# FISH PASSAGE CENTER

## MEMORANDUM

RE: Review 2011 Acoustic Tag study design for John Day Dam

Figure 1. Modified from Figure 2 (Anon. 2011). Schematic of the Virtual-Paired Release model for a single dam. Shaded areas of potential handling/tagging effect added by Fish Passage Center.

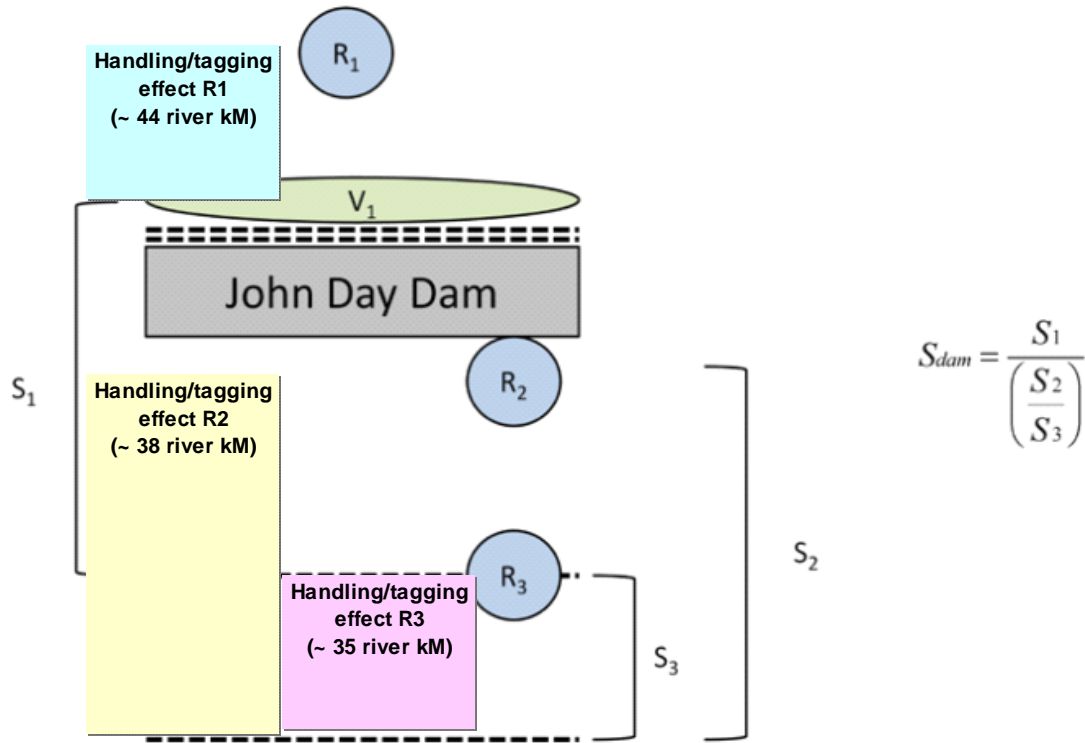
These two assumptions are: (i) the handling/tagging effects for release  $R_1$  is expected to be zero by the time these fish are re-counted as virtual release 1 ( $V_1$ ); (ii) the handling/tagging effects on  $R_2$  and  $R_3$  are expected to be equal and cancel out in the calculation of dam survival ( $S_{dam}$ ).

The handling/tagging effects on  $R_2$  may be more than those of  $R_3$  for two reasons. First, the approximate river kilometers where handling/tagging effects could be expressed are greater for  $R_2$  than  $R_3$ . The amount of handling/tagging bias, and duration over which it is expressed is unknown. However, since the unadjusted survival of  $R_2$  is measured over a longer reach than for  $R_3$ , this could bias the survival for  $R_2$  low. Second, there is no accounting for any interaction between tagging/handling effect and where the release takes place. One working hypothesis could be that handling/tagging effects have a more negative effect on the subsequent survival in an area that ostensibly contains high predator numbers (e.g. tailrace of a dam) than for downstream releases. Both of the above potential negative biases of  $S_2$  would cause the measurement of  $S_{dam}$  to be biased high. This relationship can be shown with a simplification of the equation shown in Figure 1:

$$\uparrow S_{dam} = \frac{S_1 * S_3}{\downarrow S_2}$$
